January 20, 2023

Re: 2022 Annual Inspection Report for Yankee Doodle Tailings Impoundment and Corrective Action Plan for Recommendations

Figure 1 Proposed Alluvium Facing

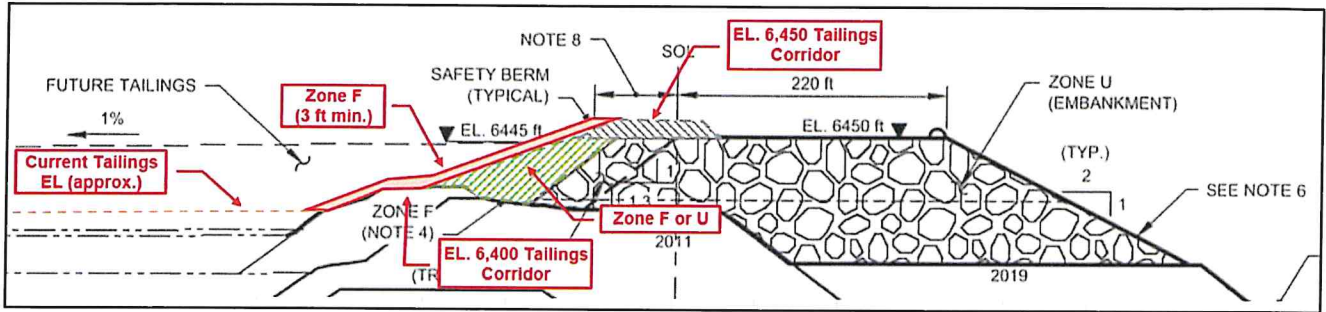
- 3. Regrade the upstream slope of the embankment during relocation of the tailings delivery pipelines (Lines 2 and 3) to the tailings pipeline corridor for EL. 6,450 ft lift. Regrade the embankment upstream slope to cover and incorporate the tailings pipeline bench along the EL. 6,400 ft lift. Implement the alluvium facing layer between the crest of the pipeline corridor along the EL. 6,450 ft lift and the upstream alluvial facing of the EL. 6,400 ft lift along the regraded upstream slope prior to cutting off access with placement of the tailings pipelines. The intent is to create a continuous layer of alluvium between the EL. 6,450 pipeline corridor and the alluvium facing previously placed as part of the EL. 6,400 ft lift construction. This recommendation applies to the portion of the East-West Embankment in the Central Pedestal Area to the east of approximately Section 23+00NW (Discharge location EW-1) and the entire North South Embankment.**

MR and KP discussed the methodology for placement of alluvium materials (Zone F) along the upstream slope of the embankment during the EOR annual inspection. The EL. 6,450 ft Issued for Construction (IFC) drawings indicate that the upstream slope of the Zone U and Zone F placement are to be field fit to maintain separation between the future tailings mass and the embankment rockfill zone, with a minimum nominal thickness of 3 ft alluvium.

The process of regrading the upstream slope and placing the alluvium by dozer (instead of dumping) is expected to enhance performance of this layer, particularly along the interface between the EL. 6,400 ft crest and base of the EL. 6,450 ft lift where segregated coarse rockfill is typically present due to the method of construction. Following construction of the EL. 6,450 ft embankment and tailings discharge corridor, MR will systematically relocate the tailings delivery pipelines from EL. 6,400 to EL. 6,450 ft allowing for additional U (rockfill) or F (alluvium) materials to be placed along the upstream face of the embankment. Figure 1 below outlines the proposed placement of materials, maintaining a minimum nominal thickness of 3 ft of alluvium along the entire upstream face.

MR will initiate sloping and placement of Zone F in Q1 of 2023, across the Central Pedestal Area east of Discharge 3-1. This will result in Discharge 3-1 temporarily being the furthest east discharge location. Upon completion of facing material along the Central Pedestal Area, MR in consultation with the EOR will determine if sloping and Zone F placement can be continued without snow cover on the tailings beach to control fugitive dust emissions, or if Line 3 is reconnected and the discharge line continues to be operated along the North-South Embankment on the EL. 6,400 pipe bench until site conditions are suitable to continue construction.
